Project	IEEE 802.16 Broadband Wireless Access Working Group < http://ieee802.org/16 >
Title	OFDMA PHY AAS Enhancements
Date Submitted	[2004-03-13]
Source(s)	<p>Panyuh Joo, Seungjoo Maeng, Jaeho Jeon, Soonyoung Yoon, Jeong-Heon Kim, Jaehyok Lee, Myungkwang Byun, JeongTae Oh, Wonil Roh, Inseok Hwang, Jaehee Cho, Sanghoon Sung, Hun Huh, Jiho Jang, Ikbeom Lee, HeeSang Seo, Sijun Cho, Chiwoo Lim, Youngbin Chang, Jaeweon Cho, Jaeyoel Kim, Sung-Eun Park, Samsung Electronics Co. Ltd.</p> <p>John Liebetreu, Jeff Foerster, Jose Puthenkulam, Randall Schwartz, David Johnston, Hassan Yaghoobi, Intel Corporation</p>
Re:	Working Group Review of P802.16-REVd_D3
Abstract	
Purpose	To propose AAS related enhancements to the OFDMA PHY in 802.16REVd_D3 draft for better performance in a broad set of channel widths.
Notice	This document has been prepared to assist IEEE 802.16. It is offered as a basis for discussion and is not binding on the contributing individual(s) or organization(s). The material in this document is subject to change in form and content after further study. The contributor(s) reserve(s) the right to add, amend or withdraw material contained herein.

1 **OFDMA PHY AAS Enhancements**

11
 12 **Figure 1 – Frame structure for AAS**

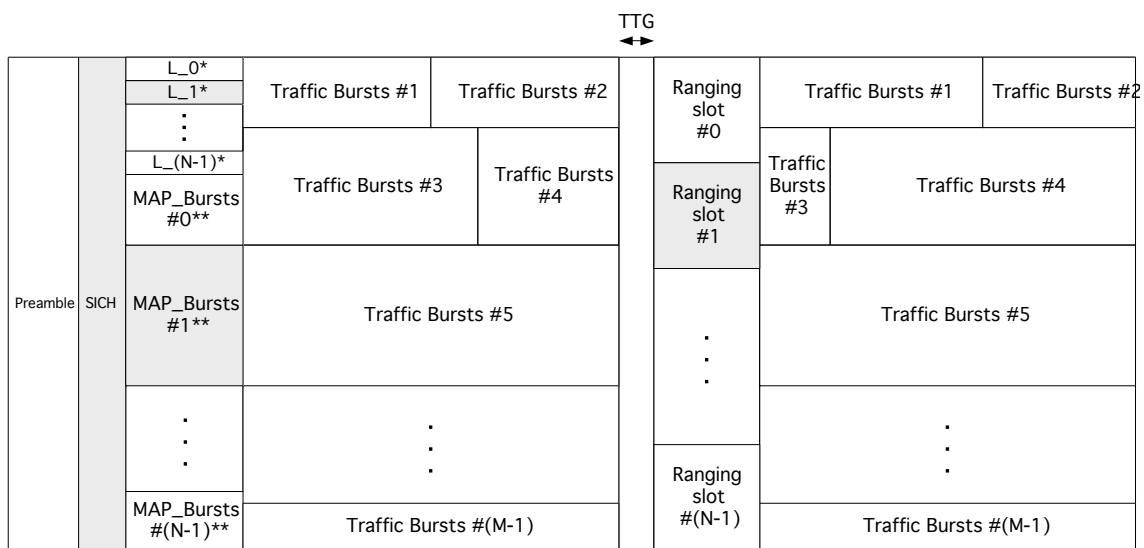
13 [Replace IEEE P802.16-REVd/D3-2004 “8.4.3.1” with the following text.]

17 When operating in the AAS mode, only AMC subchannelization is used for uplink and downlink traffic bursts. Downlink
 18 frame structure can be divided into preambles, SICH, MAP bursts, and traffic bursts. Uplink frame structure can be divided
 19 into ranging and traffic bursts. Uplink control channels may be transmitted within traffic burst region in AAS mode.

Figure 2 – Example of allocation for AAS_MAP_Burst_Location_IE

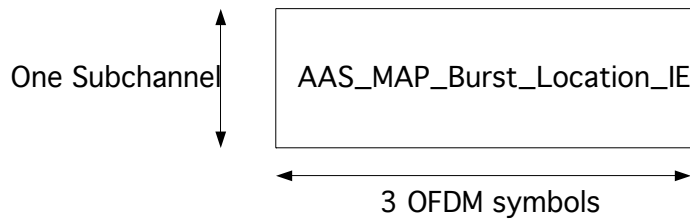
Subchannel 0 of the DL frame is used for delivering MAP allocation information. AAS_MAP_Burst_Location_IE() is transmitted in all possible beam directions. Each AAS_MAP_Burst_Location_IE() contains starting subchannel position in MAP_Burst symbols, and sizes of 3 mini_MAP_Bursts. Since AAS_MAP_Burst_Location_IE() has a fixed size and is arranged in the increasing order of beam ID, it is possible for MS to get the proper AAS_MAP_Burst_Location_IE() directing to that MS.

Physical structure for the AAS_MAP_Burst_Location_IE () is shown in **Error! Reference source not found.**. The AAS_MAP_Burst_Location_IE () is transmitted with QPSK rate 1/12.
